**DILUTER DEMAND OXYGEN REGULATOR ASSEMBLY**

**35-11-24**

TEMPORARY REVISION 35-13

TITLE: ADDITION OF PREFORMED PACKING (170)

Altitude Compensated Air Enrichment Test  
Figure 701

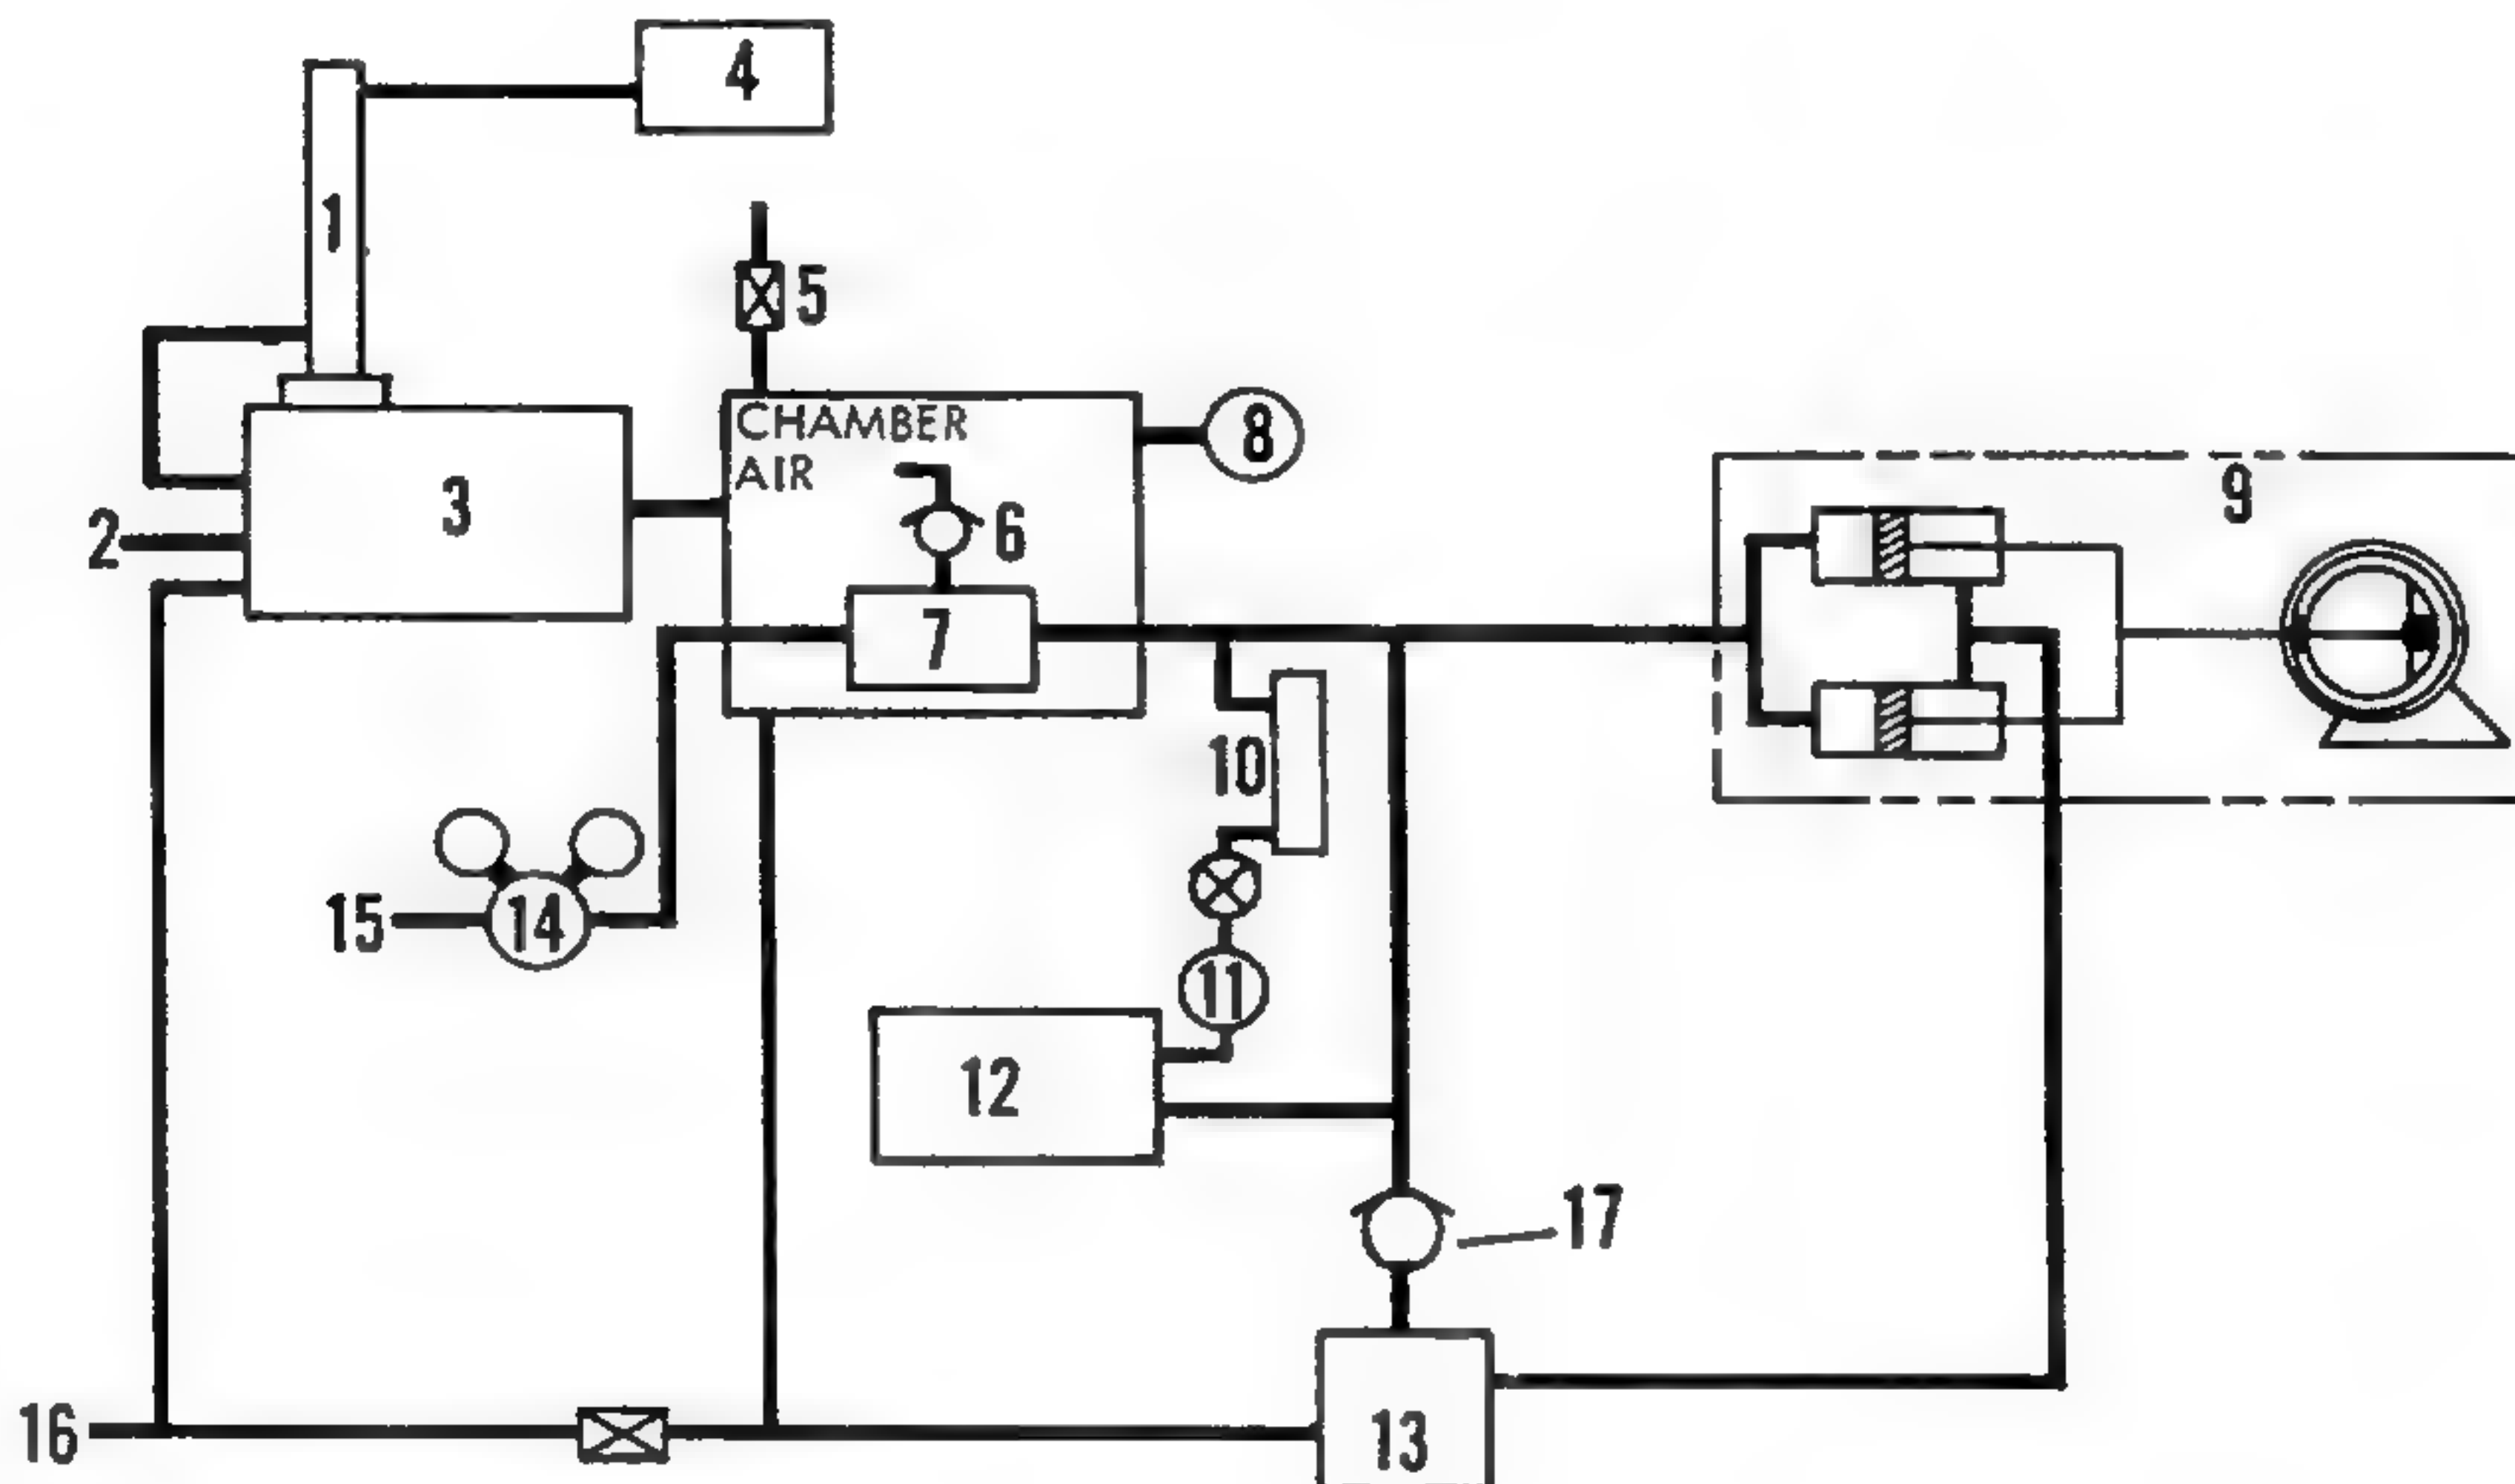
NOTE: For Figures 701, 703 and 704, equivalent test equipment may be substituted for test equipment shown.

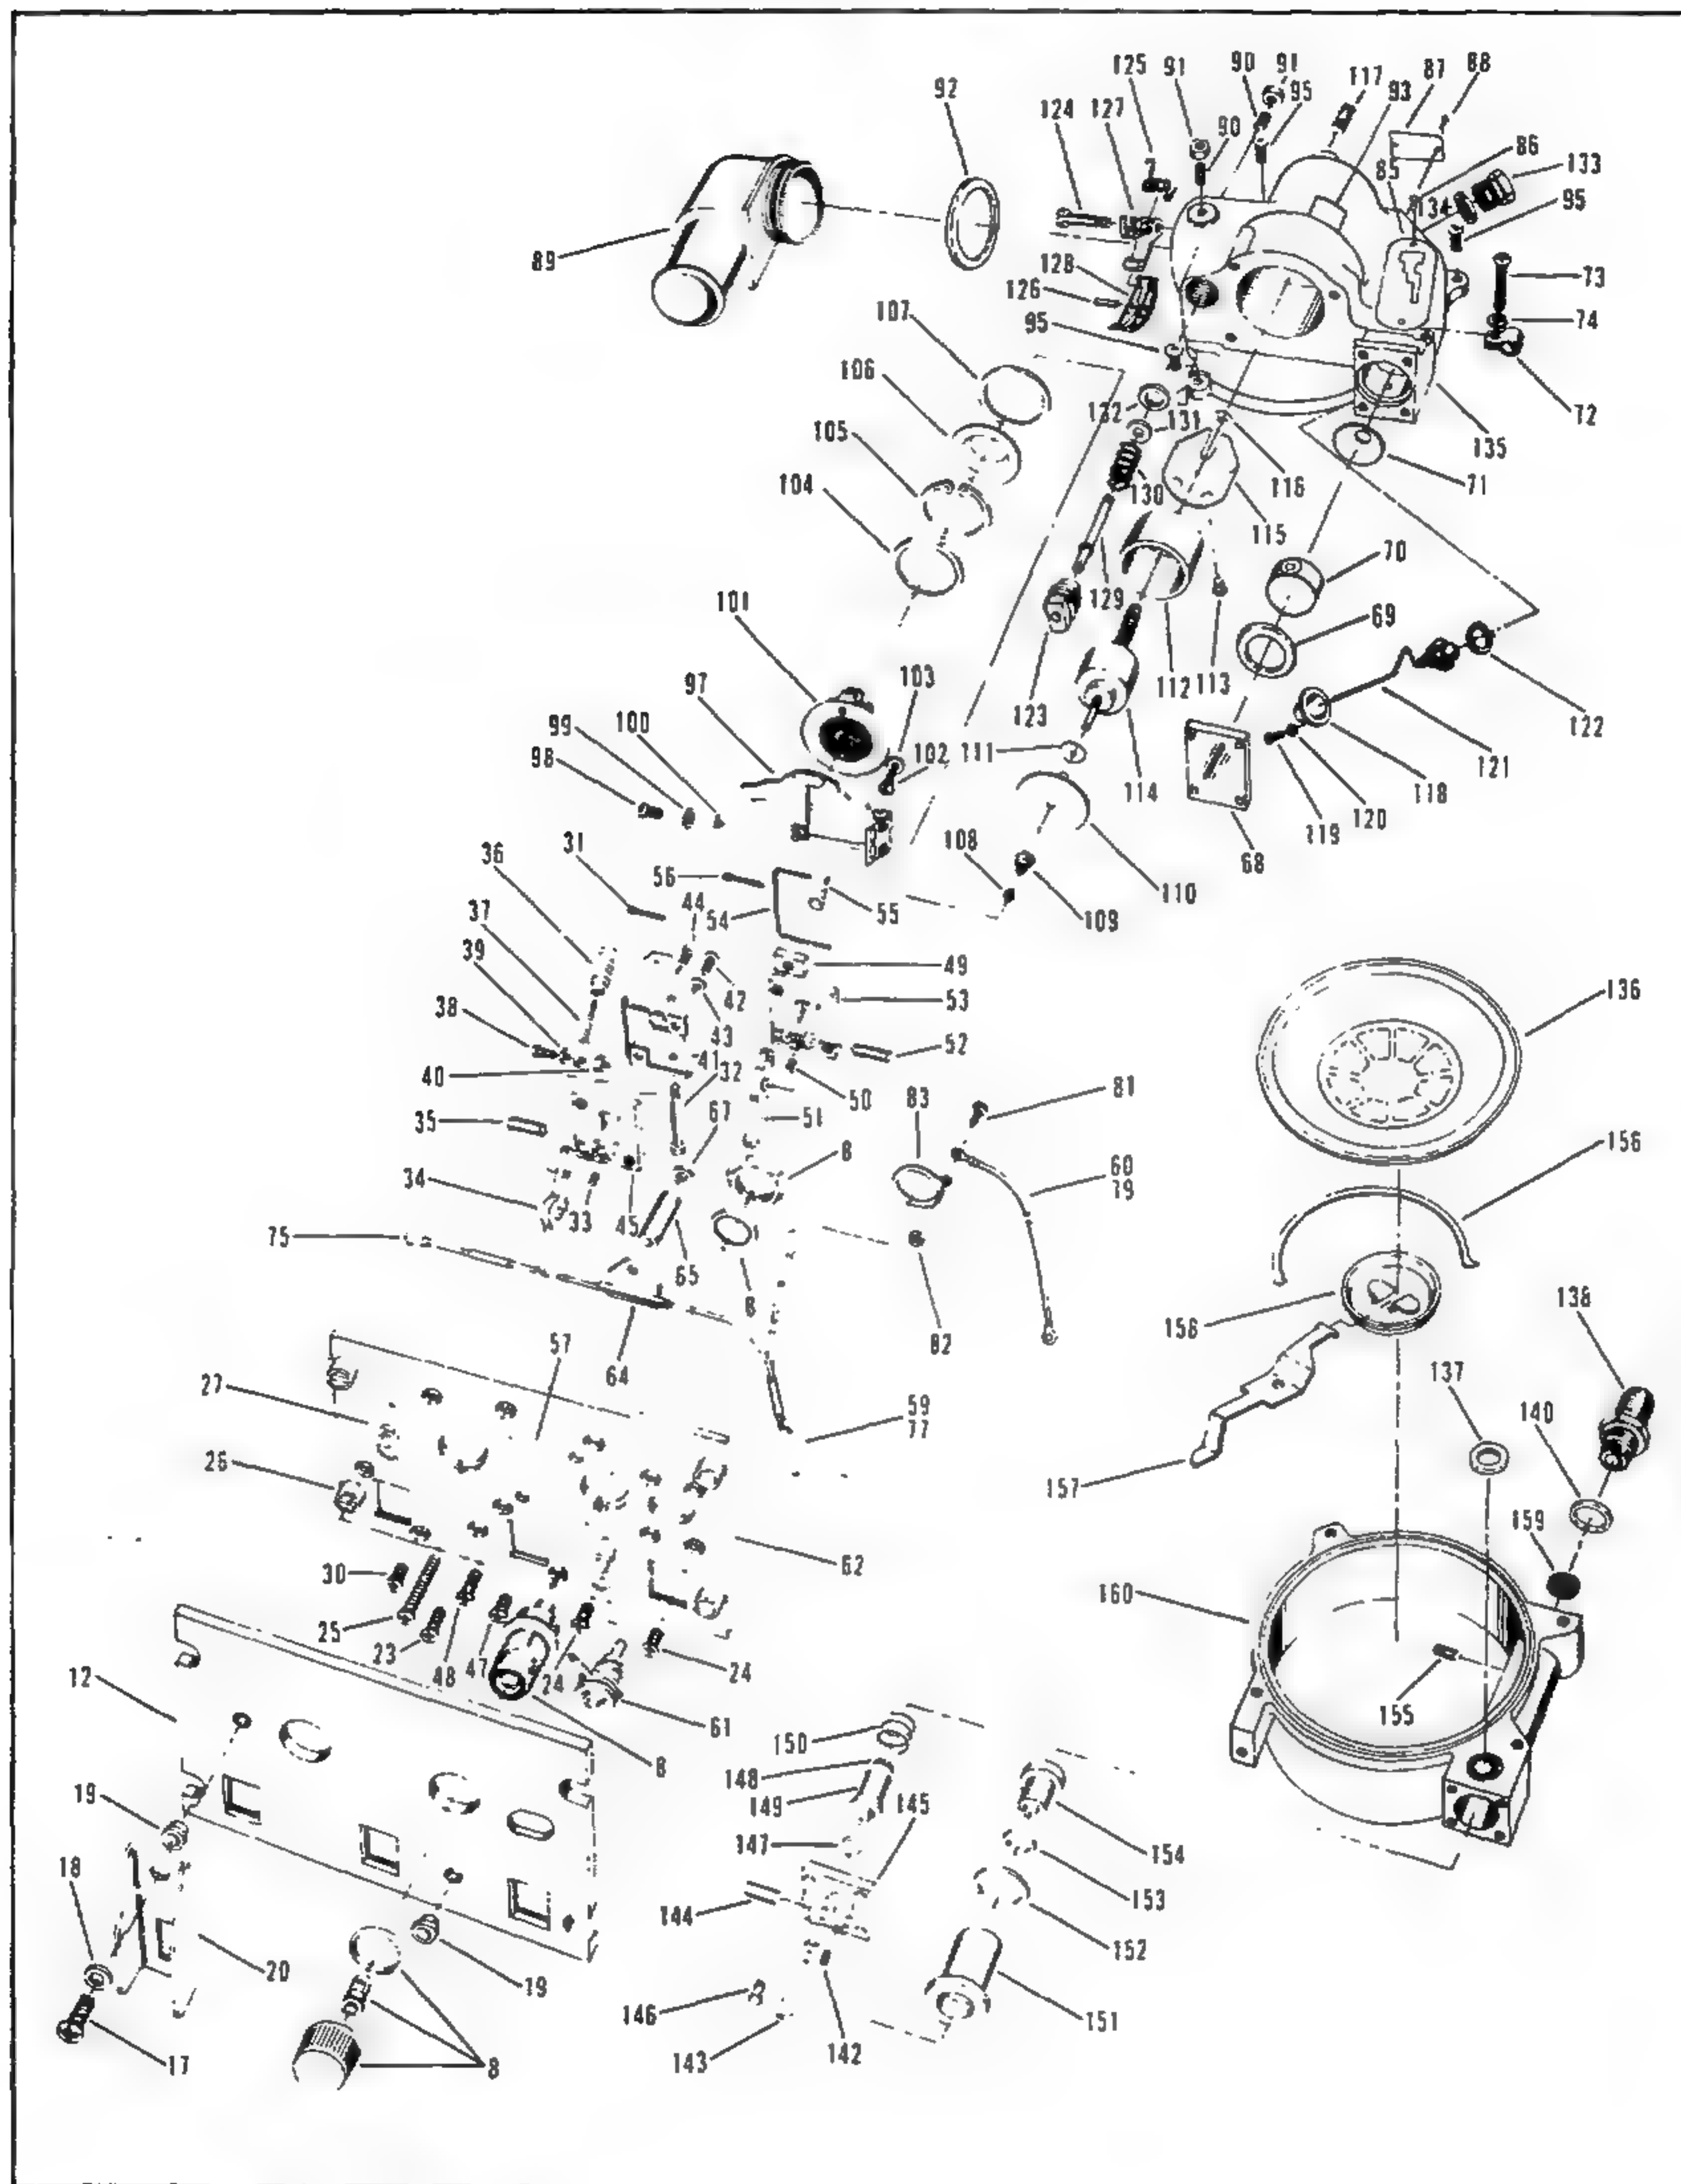
An o-ring groove was added to regulator body, part number 24897 (135, IPL Figure 1). The preformed packing (170) that is installed in that groove, seals the area between the body (135) and the aneroid housing (112), thereby facilitating the functional oxygen dilution set-up of the regulator.

**(11) Remove preformed packing (170) from body (135).**

**NOTE: Preformed packing (170) is only present in bodies  
(135) that were manufactured during, and subsequent  
to, 4Q79.**

NOTE: Bodies (135) manufactured during, and subsequent to 4Q79, have an o-ring groove within the body bore that accommodates aneroid housing (112).

Apply a thin film of Krytox 240AC lubricant to preformed packing (170) and install packing into o-ring groove of body (135).
